# Access Compliance Report

## Public Rights-of-Way

Intersection ID: 17965		Main Street: NATIONS_FORD_RD		Cross Street: SLATON_RD		Location:		NW					
ADA ID: 5462E9E929BA		Ramp Type: Directional1		Initial Pass/Fail: Fail		Overall Compliance: No		Severity Score: 1.25					
Codes/Mitigation Info/Possible Solution				Field Measurements/Component Compliance									
				Possible Solutions:		Compliance		Description		Data			
				Remove & Replace Entire Ramp.		N/A		Ramp Length (in)		64.0		N/A	
						Yes		Ramp Width (in)		79.0		N/A	
						Yes		Ramp Slope (%)		6.4		N/A	
						No		Ramp XSlope (%)		4.3			
						N/A		Flare Type LT		N/A		N/A	
						N/A		Flare Slope LT (%)		N/A		N/A	
						N/A		Flare Traversable LT?		N/A		N/A	
						N/A		Landing Length (in)		0.0		N/A	
						N/A		Landing Width (in)		0.0		N/A	
Surveyor Notes:  N/A						N/A		Flare Type RT		N/A			
						N/A		Flare Slope RT (%)		0.0			
						N/A		Flare Traversable RT?		N/A			
						N/A		DWS Provided?		N/A

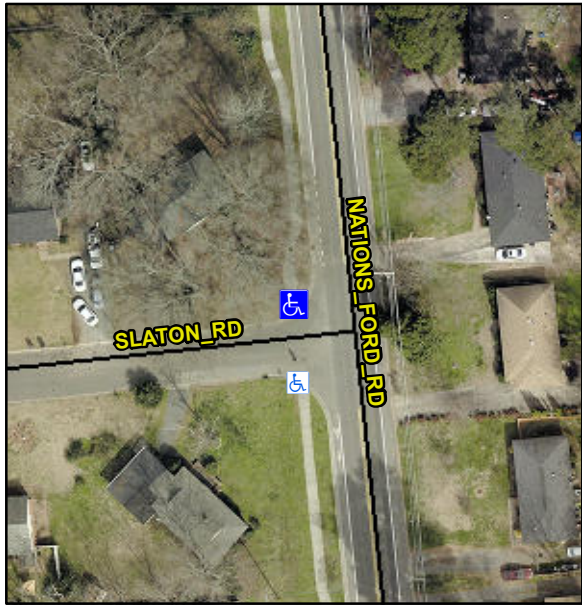
N/A		DWS Contrast?		N/A			
						N/A		DWS Length (in)		N/A			
						N/A		DWS Full Width?		N/A			
						N/A		DWS Offset LT (in)		N/A			
						N/A		DWS Offset RT (in)		N/A			
						N/A		Gutter Slope (%)		N/A			
PROW/ADA:  R304.5.3						N/A		Gutter X Slope (%)		N/A			
						N/A		Road Slope (%)		0.3			
						To SE		Road X Slope (%)		0.2			
						N/A		Clear Space?		N/A

0.3		Clear Space to XWalk (in)		N/A			
						0.2		Storm Grate/Utility Hazard?		N/A			
						N/A		Storm Grate/Utility Type					
						N/A				N/A			
								Yes		Surface Condition? (G/P)		Good	
						N/A		N/A		Curb Slope (%)		11.6
